**Warrenton Planning Commission  
AGENDA**

5. **Type 3 Public Hearing:** Bay Breeze Dog Boarding | (CUP 18-3)
  - Applicant: Brandy Gregg, Bay Breeze Dog Boarding
  - Proposal: Adaptive reuse of existing warehouse on SE 9<sup>th</sup> St

TO: Warrenton Planning Commission  
FROM: Kevin A. Cronin, AICP, Community Development Director  
RE: Bay Breeze Dog Boarding & Grooming | Conditional Use Permit (CUP 18-3)

New Site Plan  
 Bay Breeze  
 1410 SE 9th  
 Warrenton, Or 97146

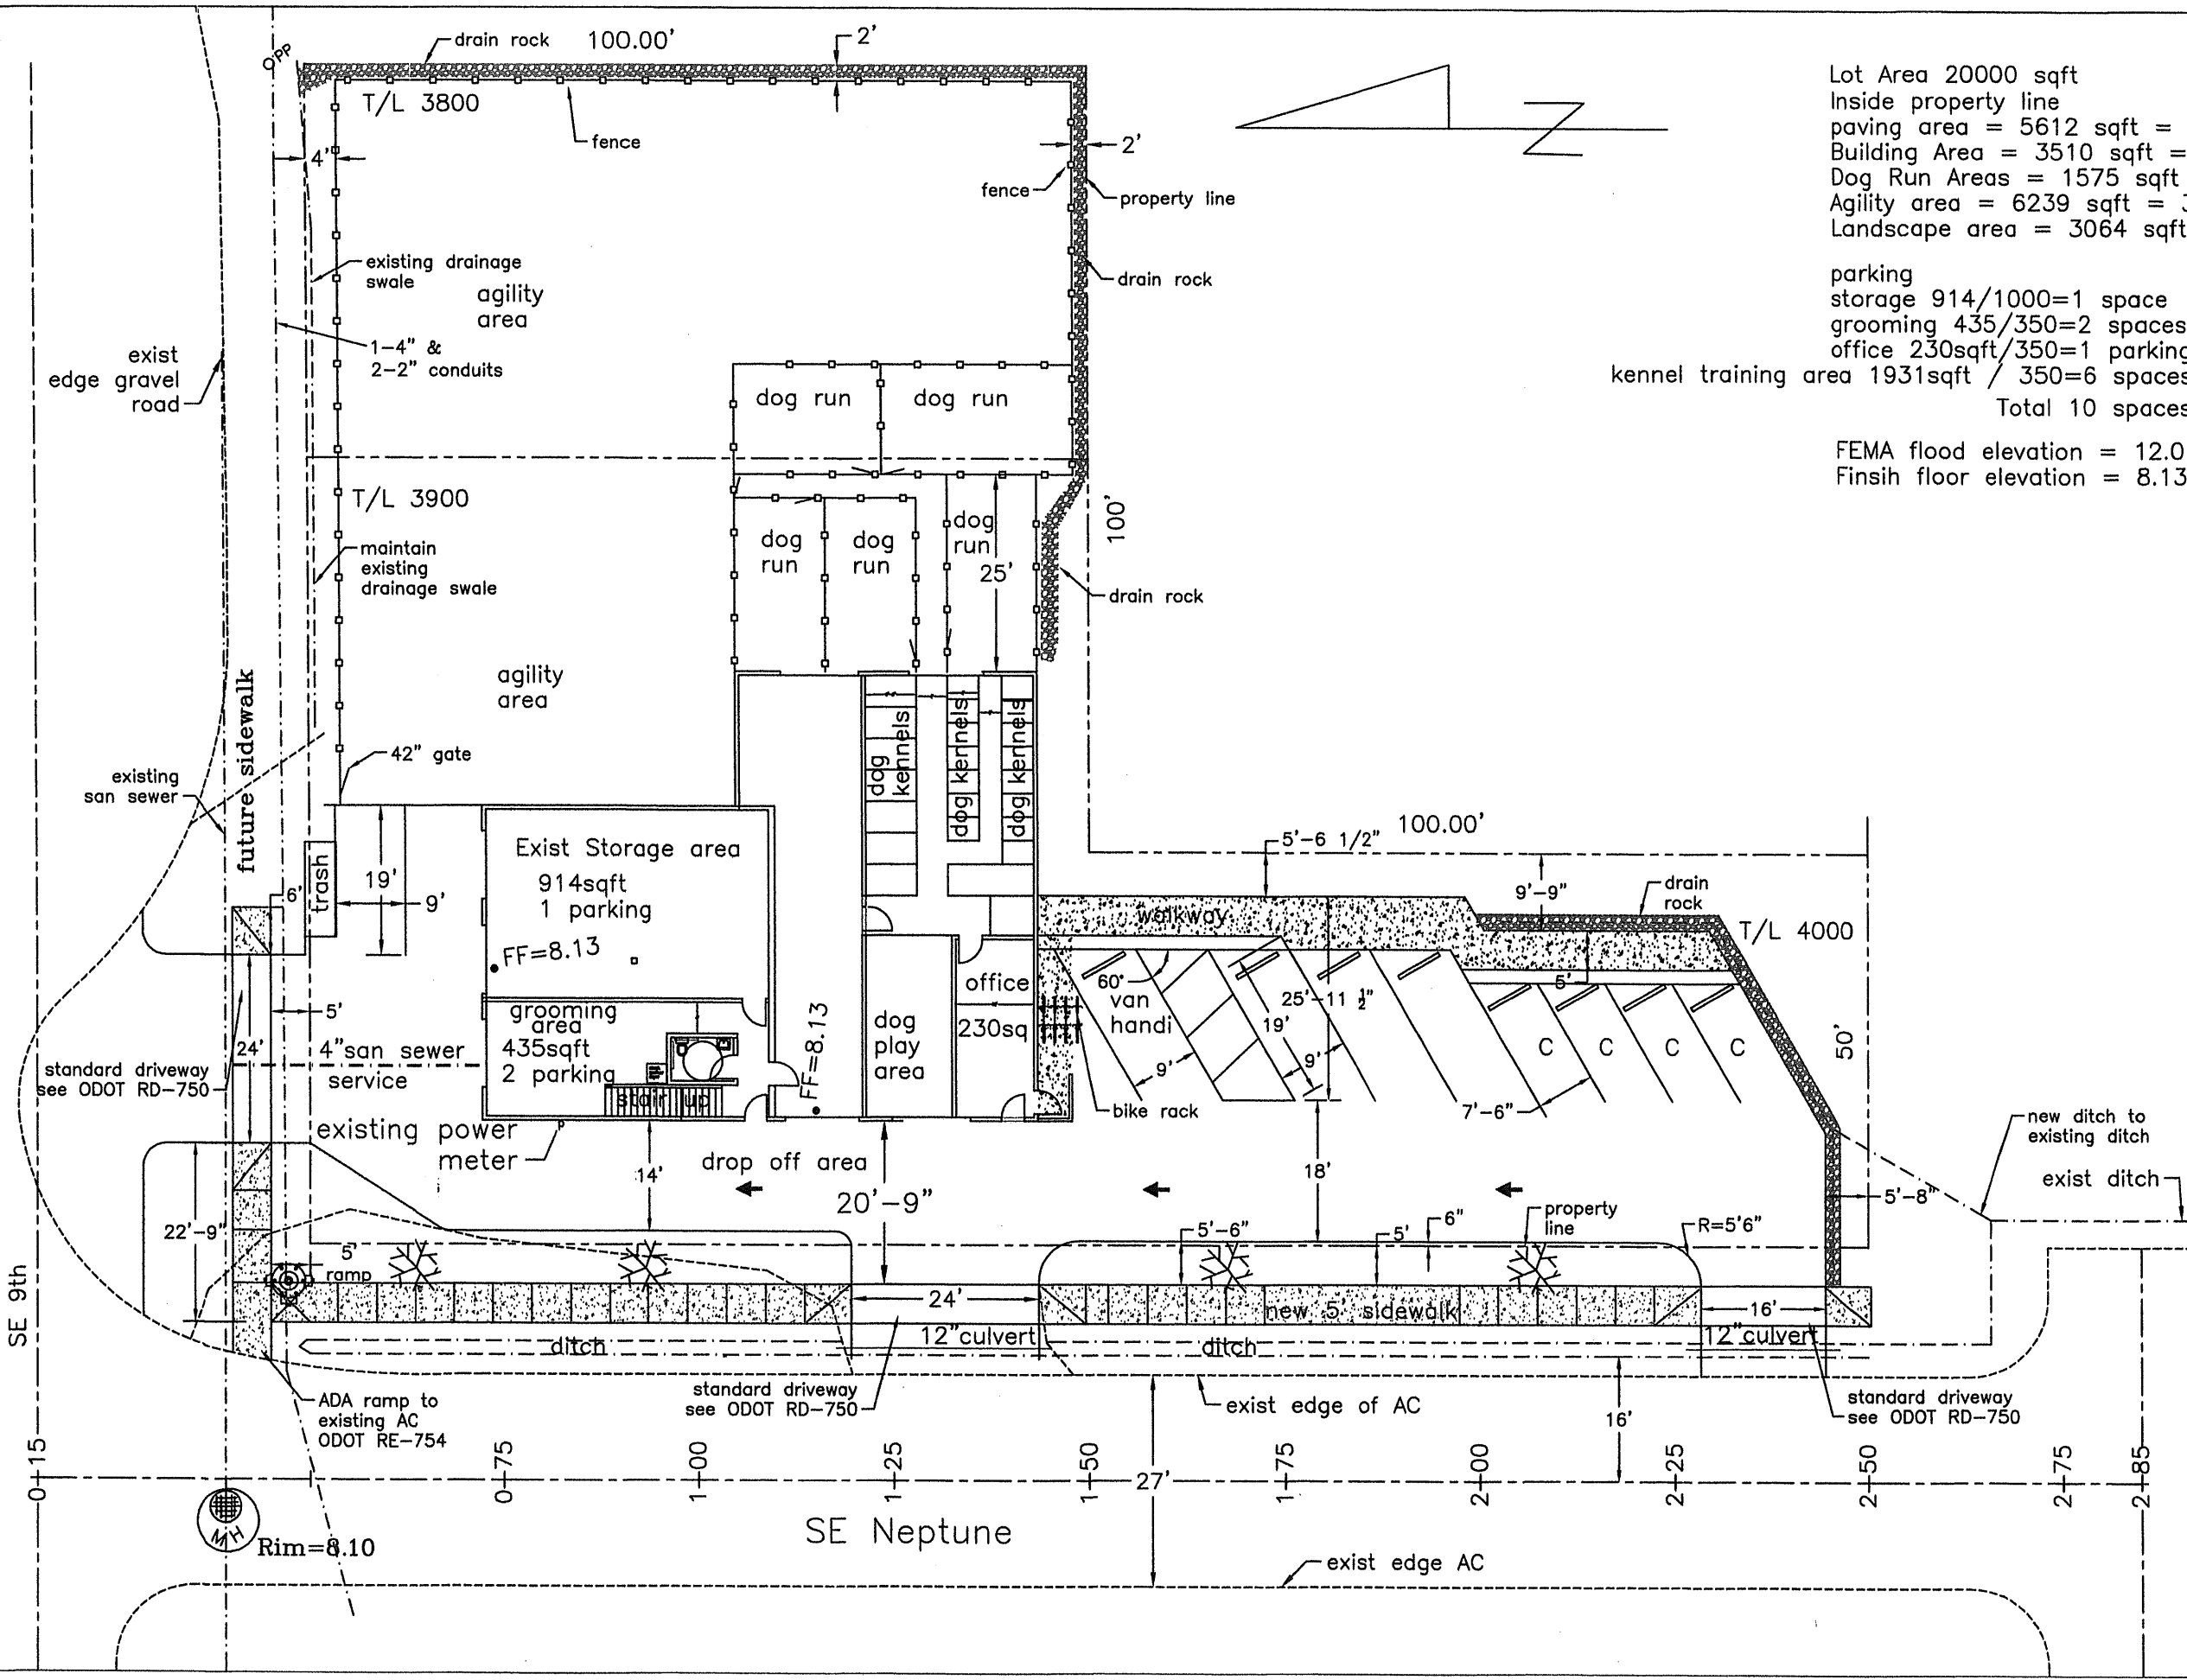
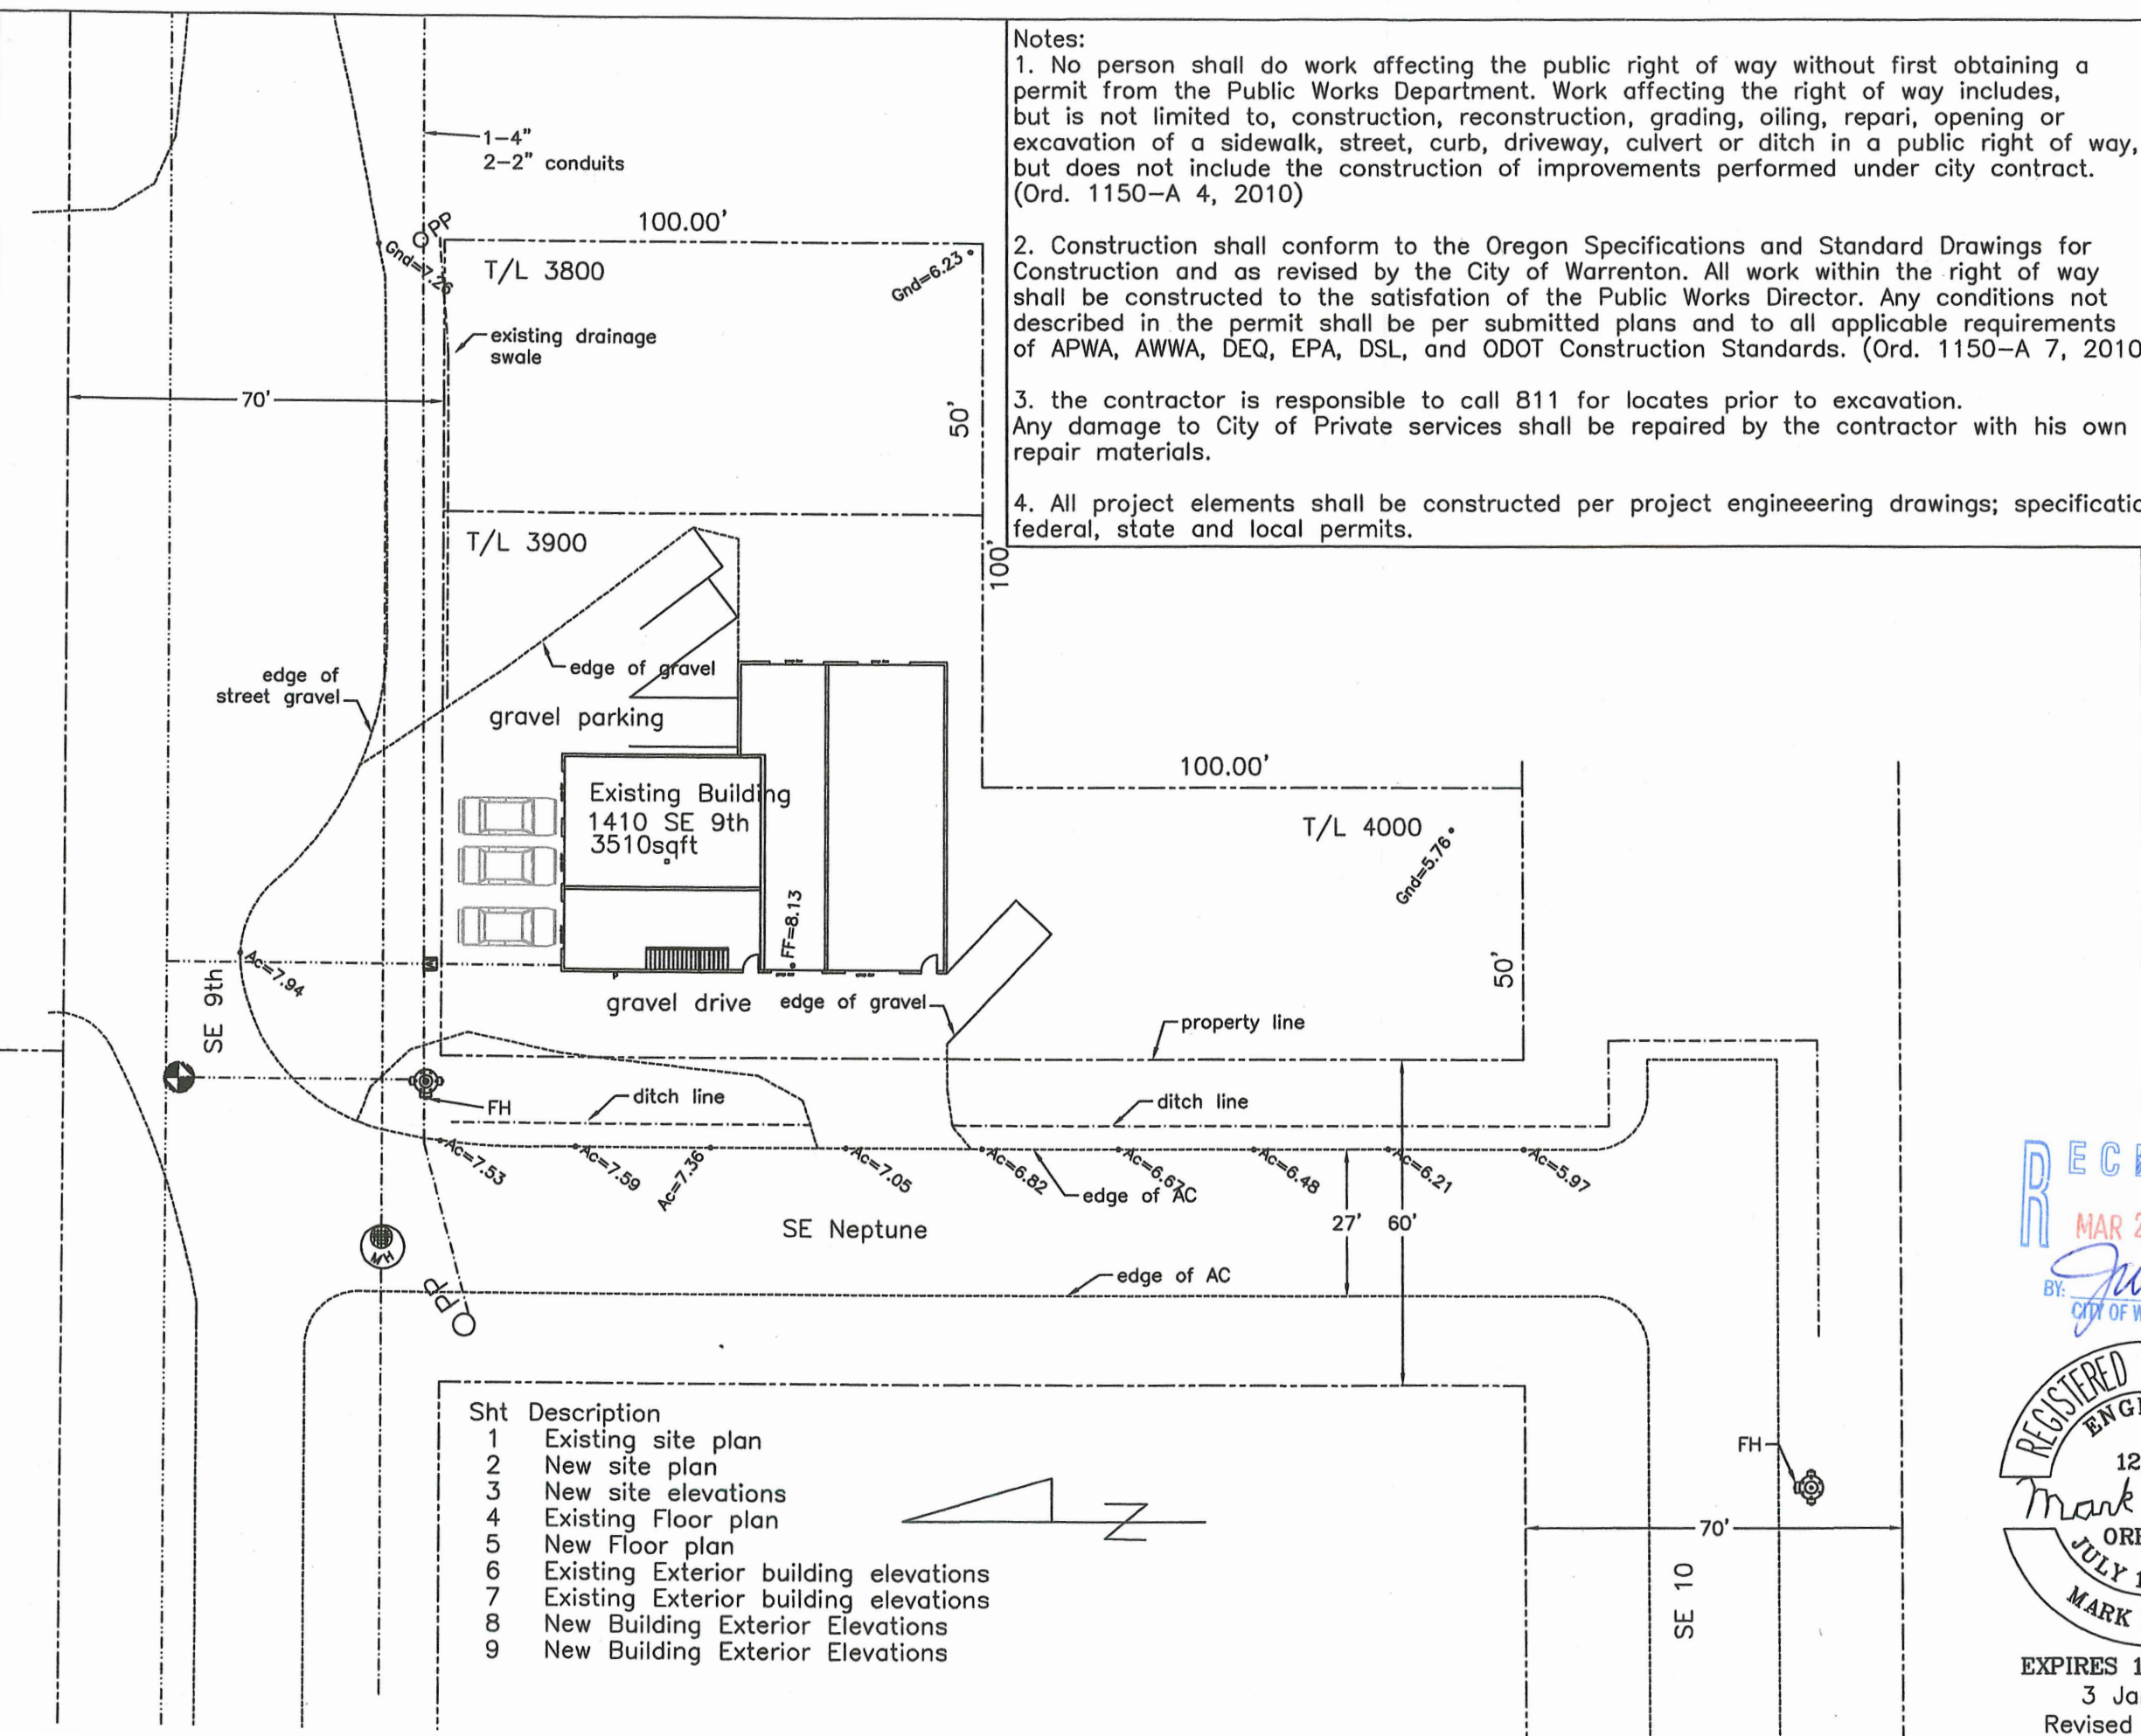
**Staff finding:** A landscape plan was submitted in March 2019 . The proposed native plant selection, tree size (2" caliper), hardscape features, and coverage standards have been met. However, non-plant ground cover is not identified on the plan. See condition of approval.

**Staff Finding:** Wheel stops are indicated on the site plan for off street parking spaces. A raised curb or wheel stops are required. Mechanical equipment is not indicated. A trash and recycling container location is illustrated on TL 3900, but no enclosure is indicated. See condition of approval.

**Staff finding:** The location of the bike rack is located close to the front entrance and does not impede pedestrians as long as the installation allows clearance. The design shall be U shaped “staple” design or similar. A long-term space for employees shall be designed for the interior of the building. Condition will be checked at building permit plan review. See condition of approval.

9. Landscape plan shall be amended and resubmitted with non-plant ground cover identified on the plan prior to building permits. Bark mulch or compost is strongly encouraged along with river rock or other distinguishing landscape features. All invasive or non-native vegetation shall be removed. Irrigation shall be installed or a copy of a two year maintenance agreement with a landscaping contractor shall be furnished. All landscaping shall be verified prior to Certificate of Occupancy.

11. The bike rack design shall be U shaped "staple" design or similar. A long-term space for employees shall be designed for the interior of the building. Condition will be checked at building permit plan review.

12. A grading and erosion control plan shall be submitted for review and issued prior to any grading permit.
13. A revised site plan illustrating required conditions of approval shall be submitted for review prior to building permit review.
